Aspire Garments Limited

24th December 2017

Observations

Concreting repair work

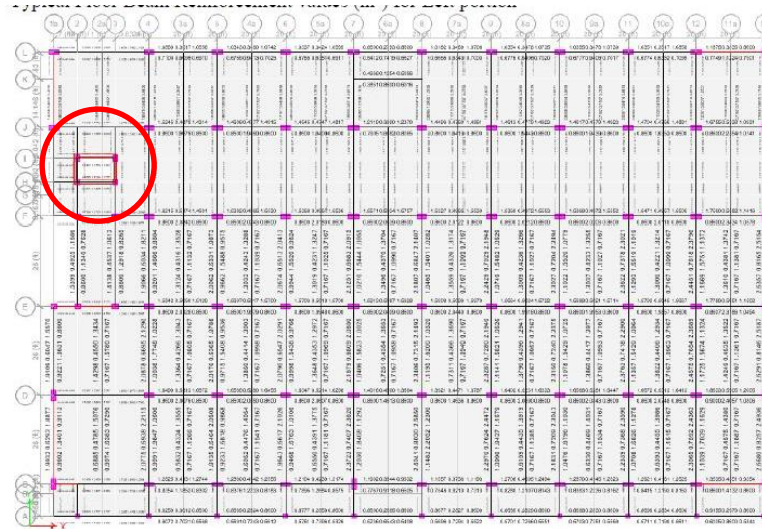
Concrete repair work around ducting facility in toilet area appeared loosen. Falling hazard may occurred direct to personal. Building engineer is required to repair the loose material works to prevent falling hazard.

Snapshots from design report

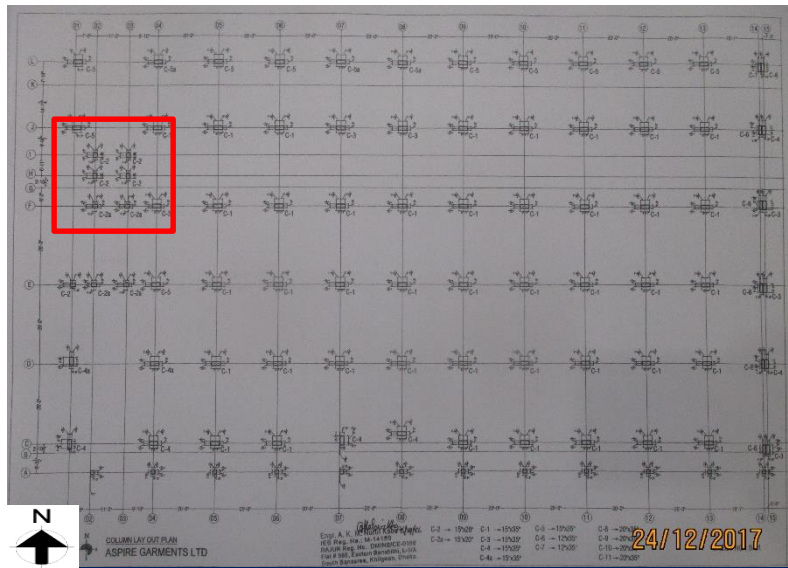
Shear walls in lift core may have designed for lateral load resisting system. In As built drawing shear wall details was not included. No evidence of shear walls was observed on visual inspection. Building engineer is required to check the shear walls are actually being built or not. If not verify the design report considering only moment resisting frame against lateral loading.

Under Ground water reservoir plan

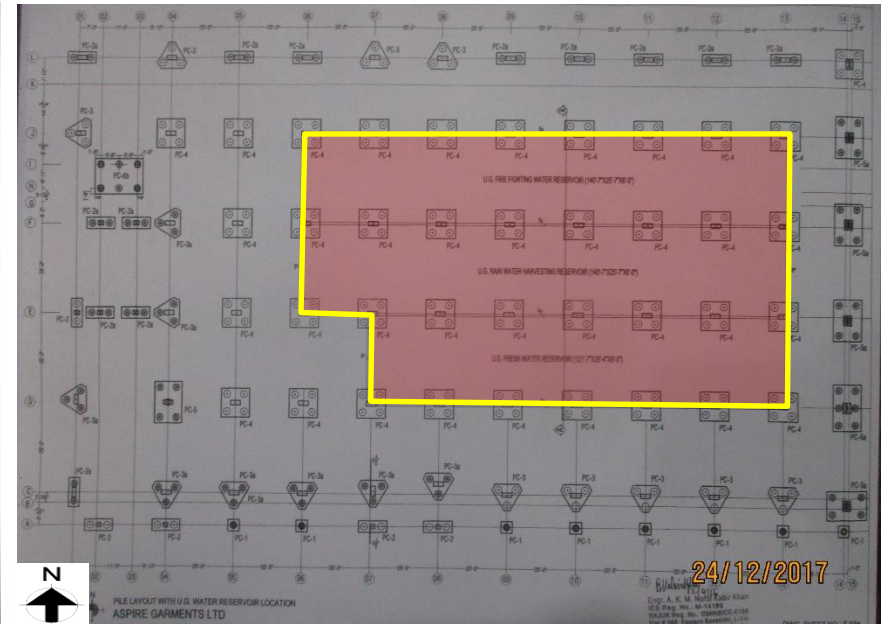
Uncontrolled live loading on suspended ground slab (Top Slab of U.G.W.R) is required to reduce.

Construction derbies were piled upon roof top

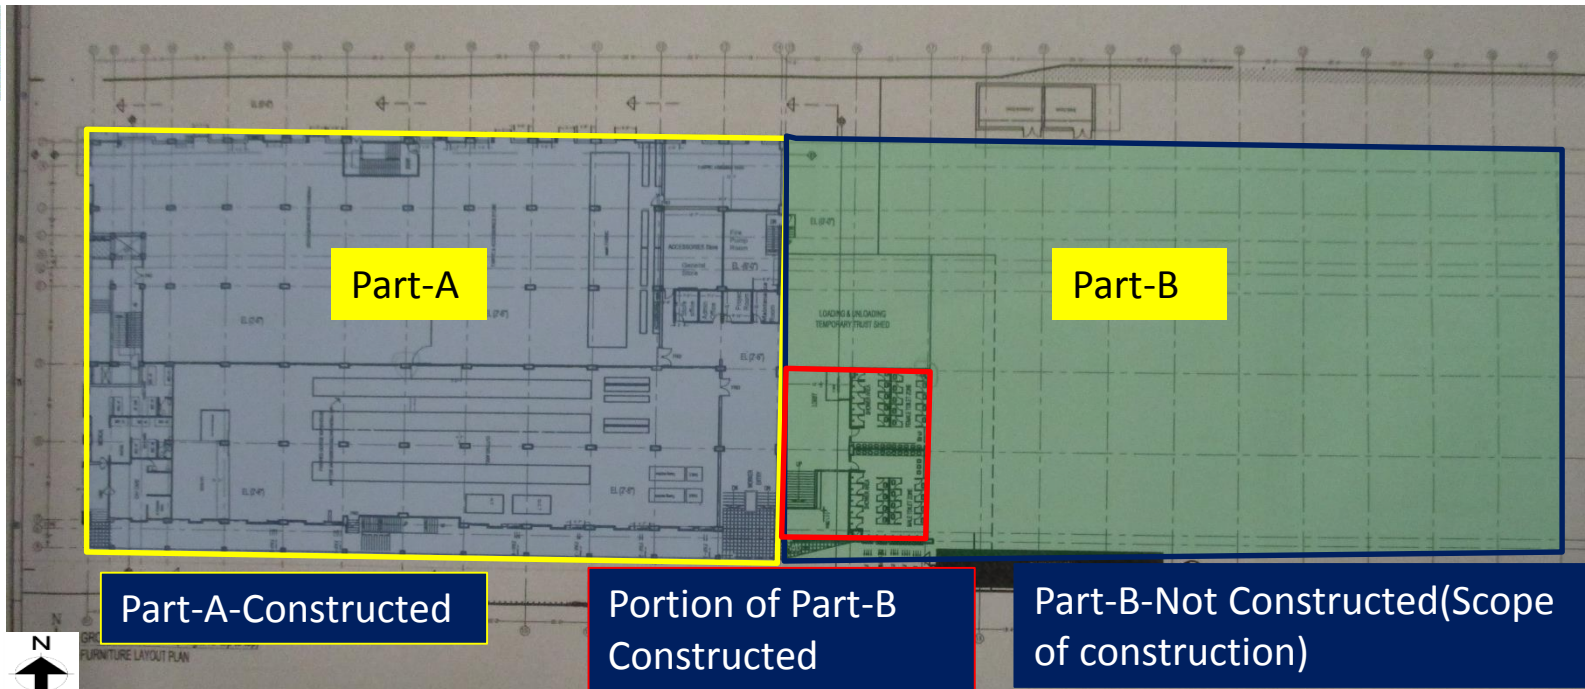
Uncontrolled construction debris piled upon on roof top. Building engineer is required to check whether the piled derbies exceeds the design load capacity or remove the debris.

Rebar exposed to weather

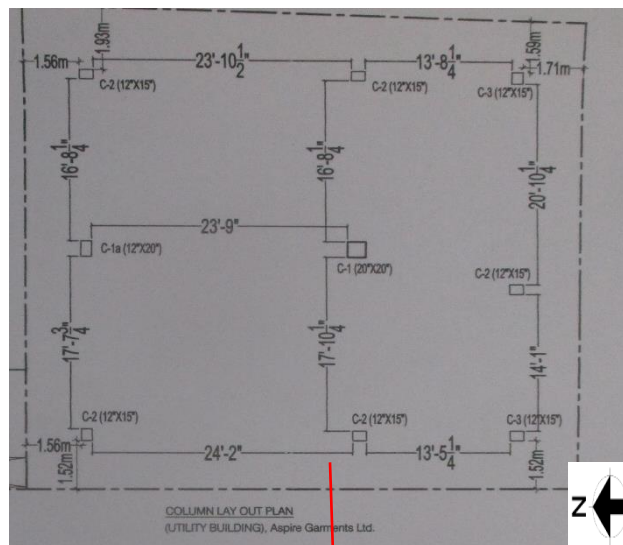
Part-B of the building will be constructed in future. Rebar kept exposed without any corrosion protection.

Column & Beam Layout

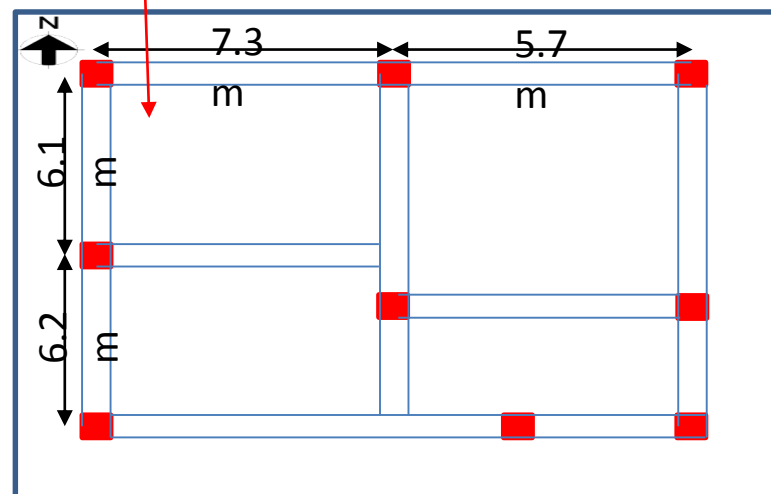
As built drawings of utility building was not reflecting with site condition

Column & Beam Layout was not matched with provided drawing.
